Los Angeles to Pasadena Metro Blue Line Construction Authority
Los Angeles to Pasadena Metro Blue Line Light Rail Project

Value Engineering Study Report

Preliminary Basis for Design/Build Design

December 22, 1999

LAR-14
Sht. 2 of 2

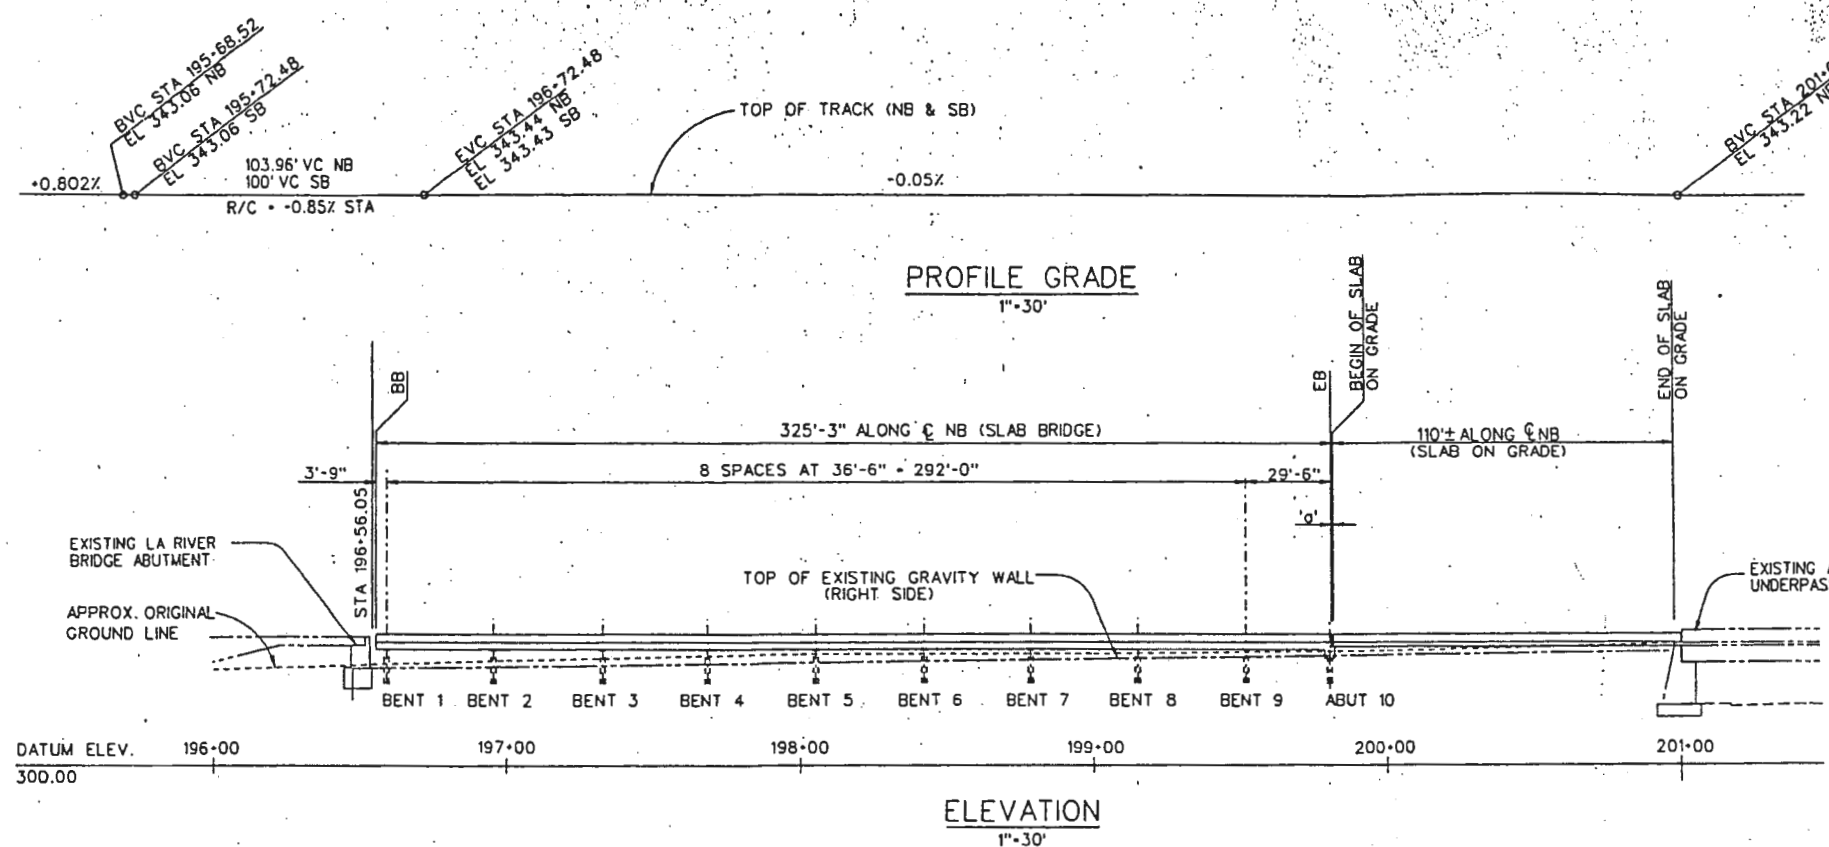
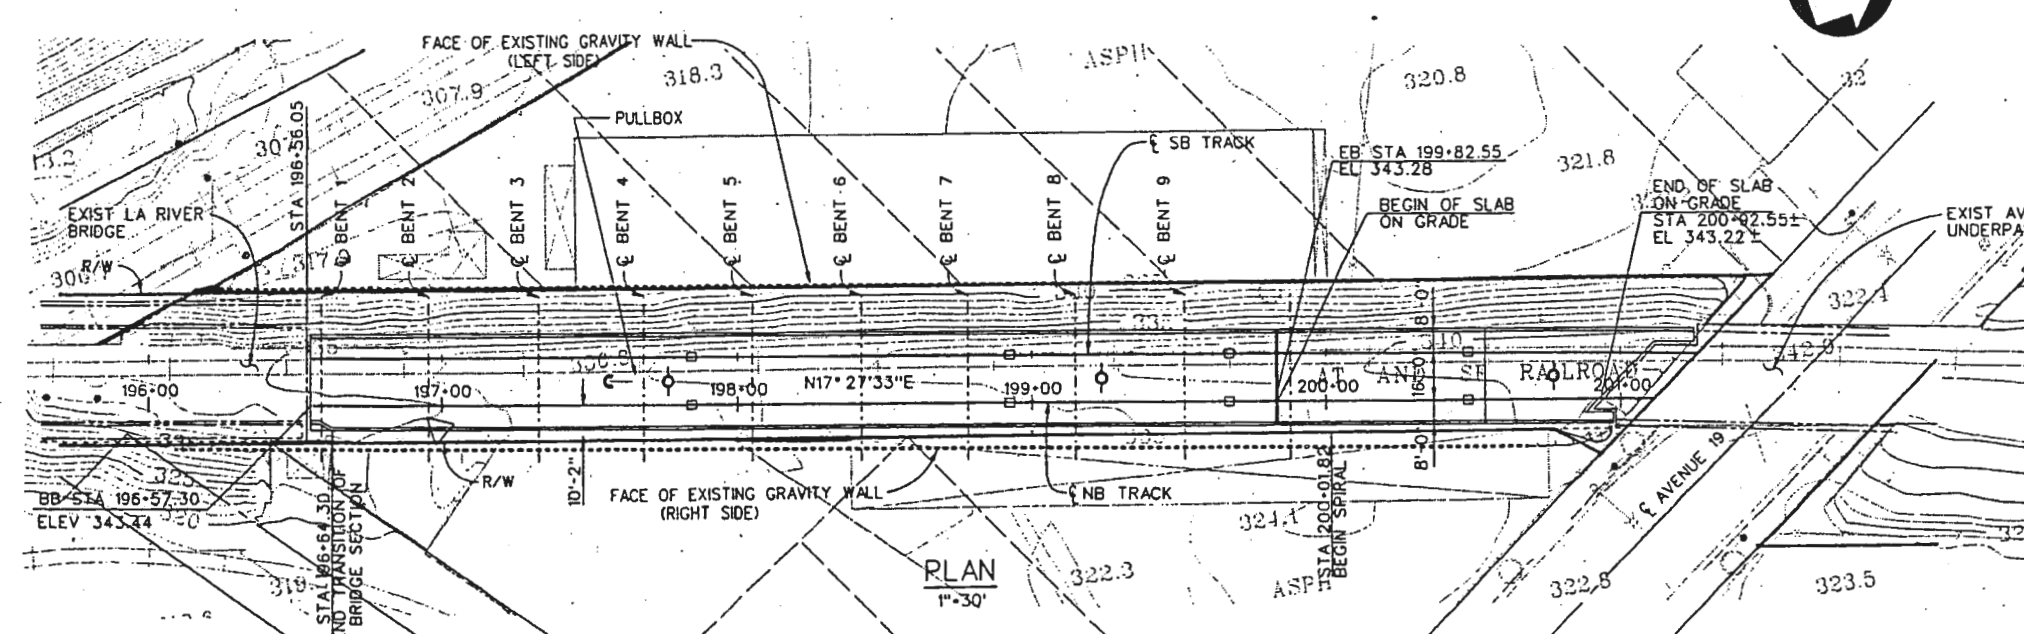
PROJECT:	PASADENA BLUE LINE LIGHT RAIL PROJECT	ALTERNATIVE NO.	LAR-14
DESCRIPTION:	MODIFY THE CURRENT DESIGN OF THE SLAB BRIDGE BETWEEN LA RIVER BRIDGE AND AVENUE 19	SHEET NO.	1 of 2

The design/build contractor should review opportunities to simplify the track support structures to reduce construction costs. Potential options include a modified slab structure or possibly additional or modified retaining walls to enable simple embankment construction with no bridge structure.

Marmion Way Corridor
Pasadena Blue Line
Phase 2
Concept Report
January 3, 1997

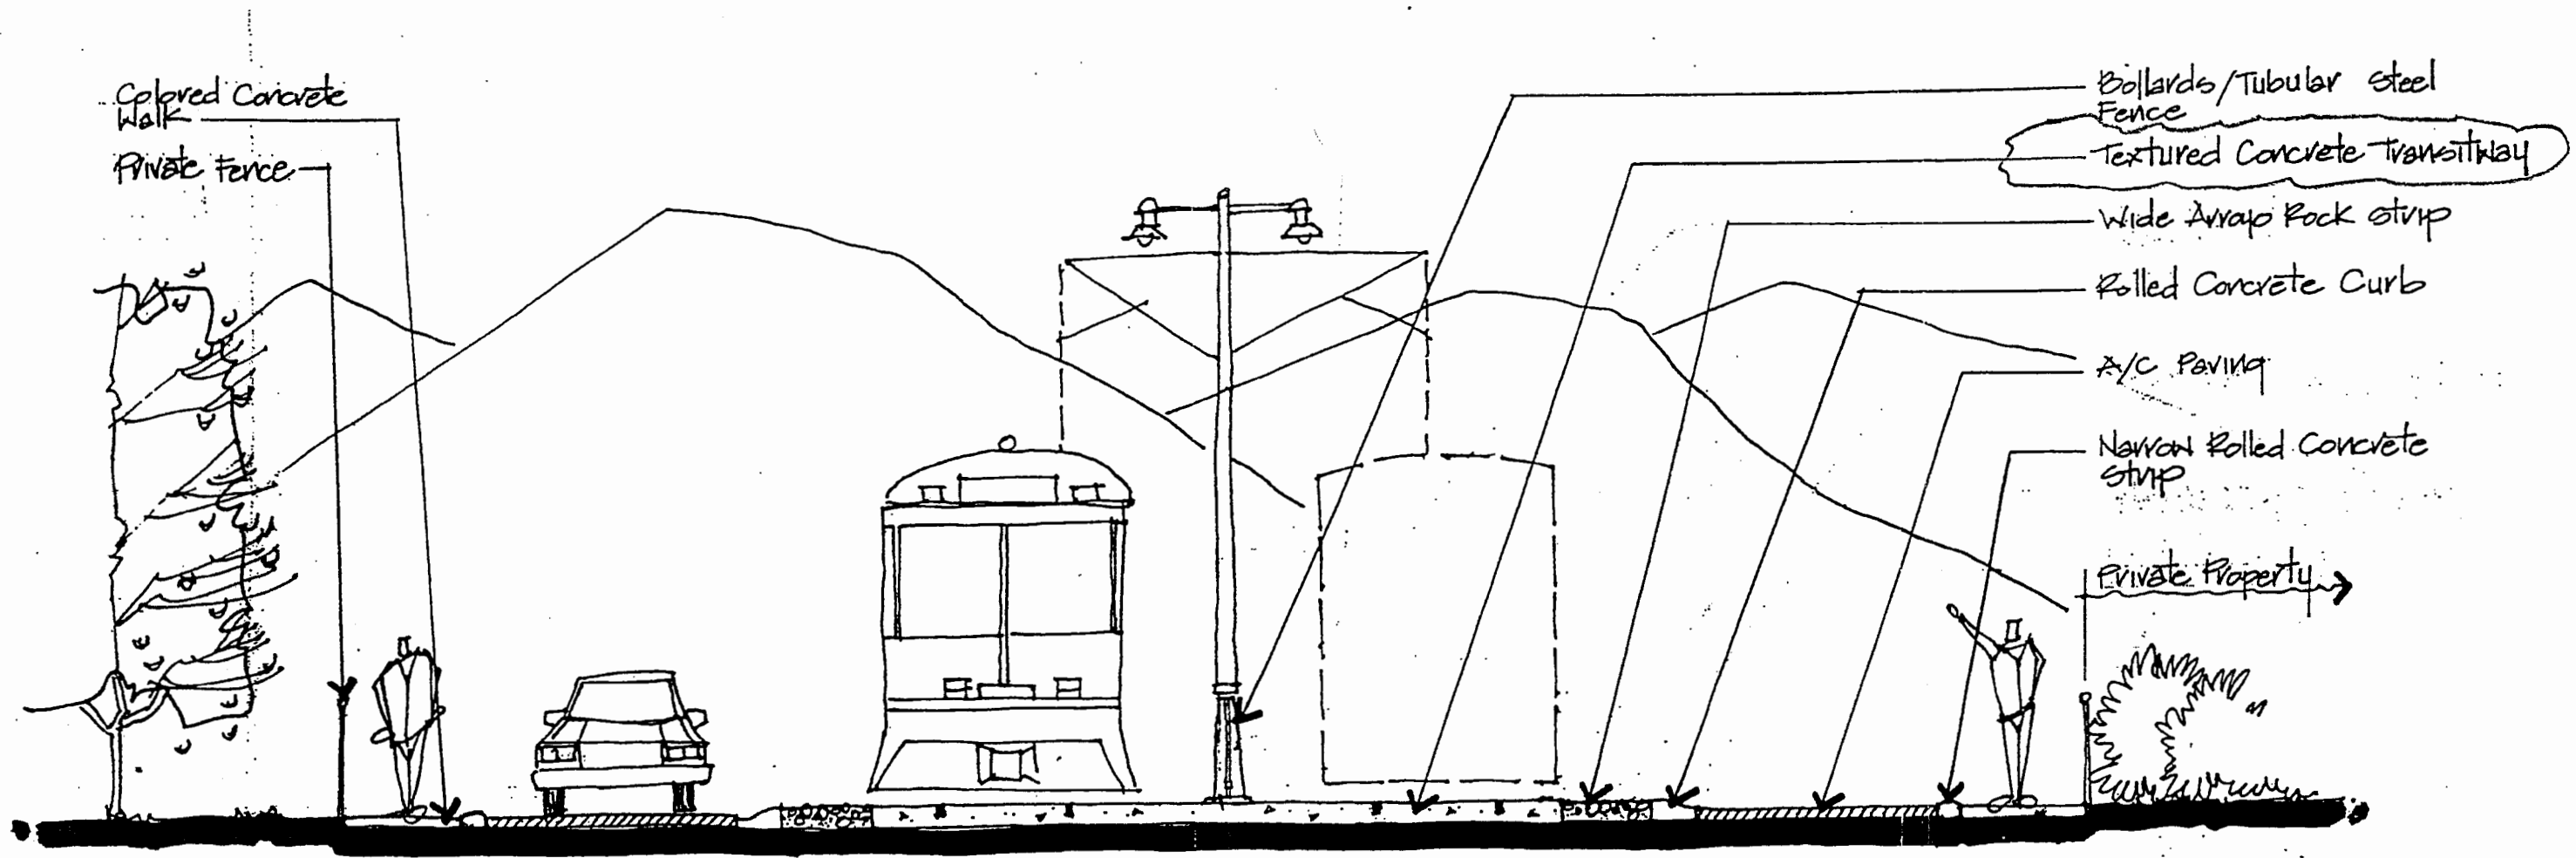
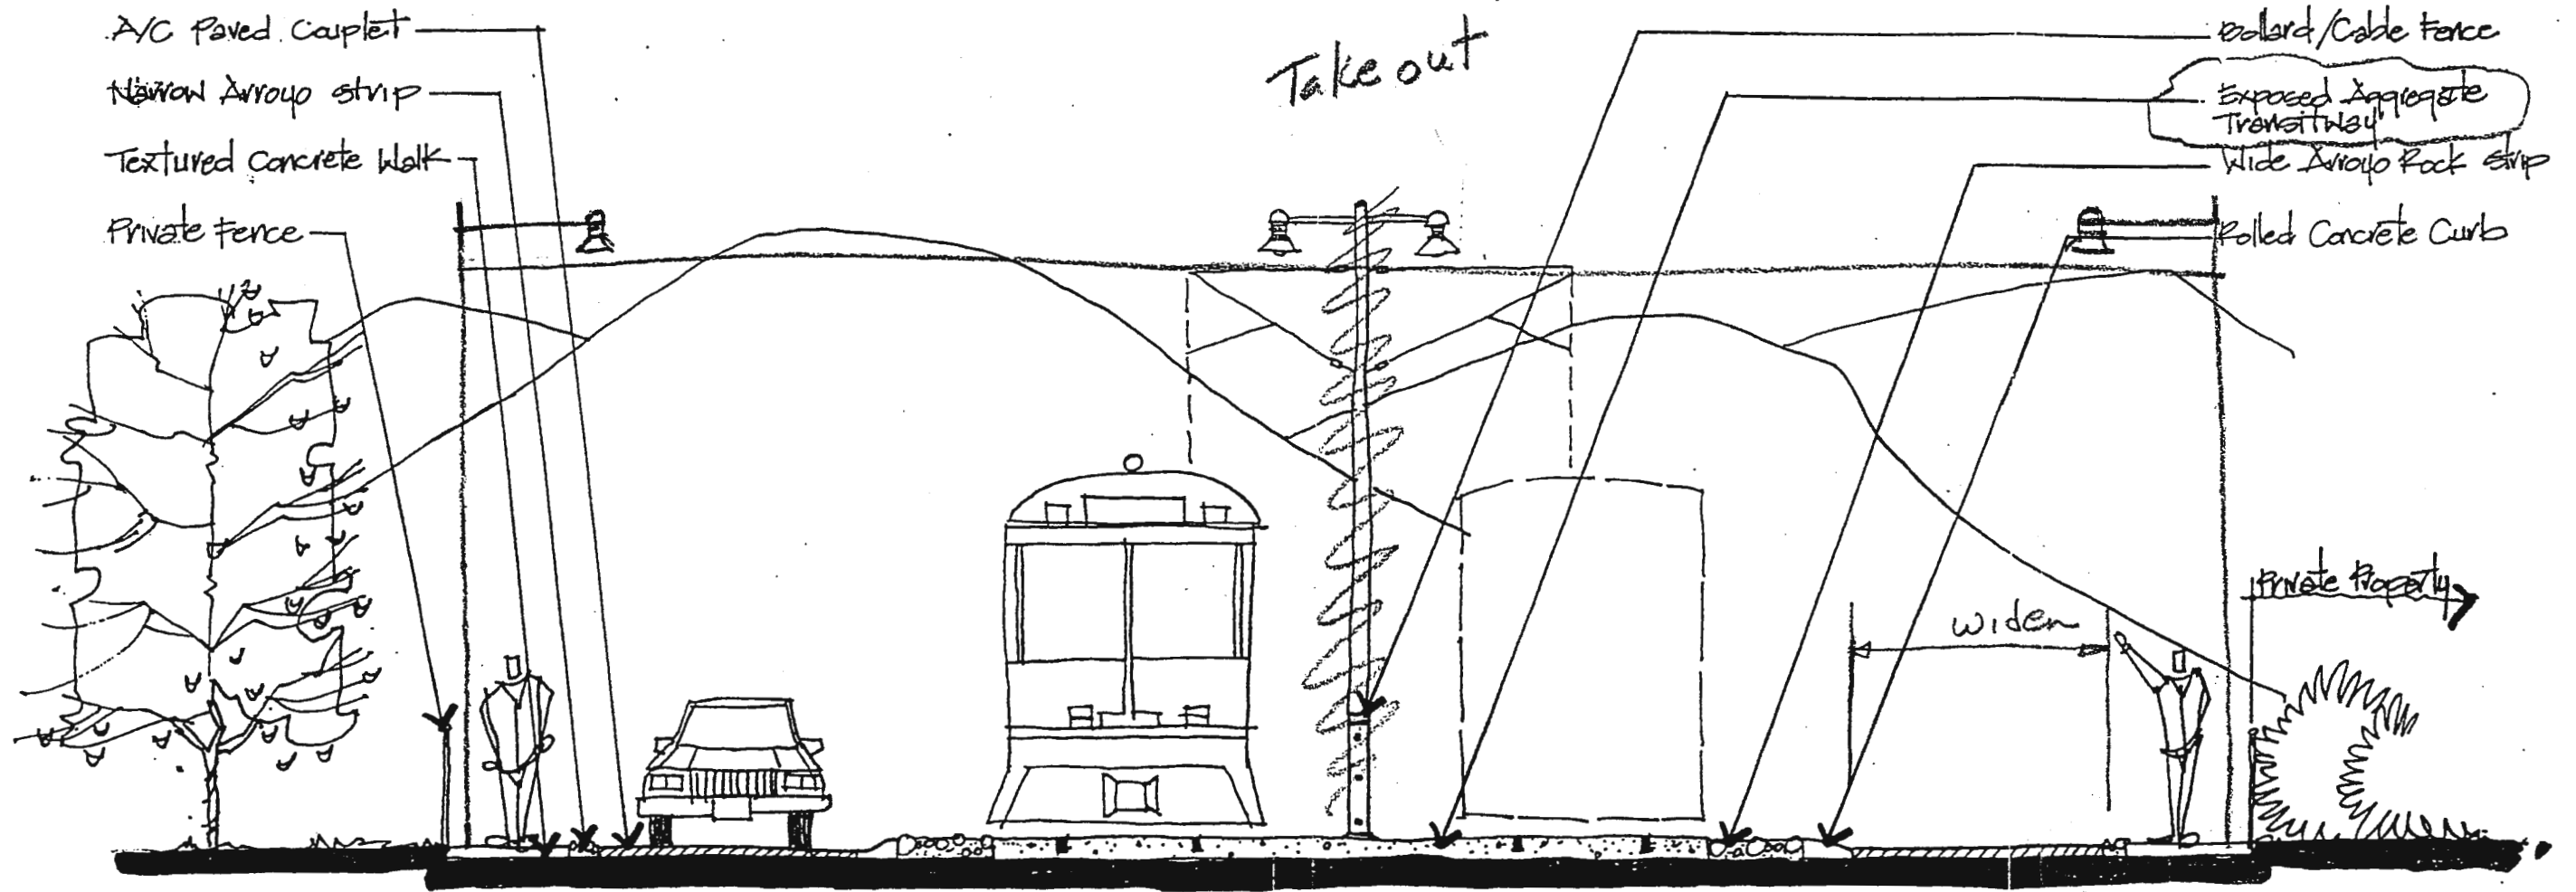
PROJECT:	PASADENA BLUE LINE LIGHT RAIL PROJECT	ALTERNATIVE NO.	LAR-15
DESCRIPTION:	DELETE EMBEDDED TRACK ON MARMION WAY FROM 51 AVENUE TO 57 AVENUE	SHEET NO.	1 of 3
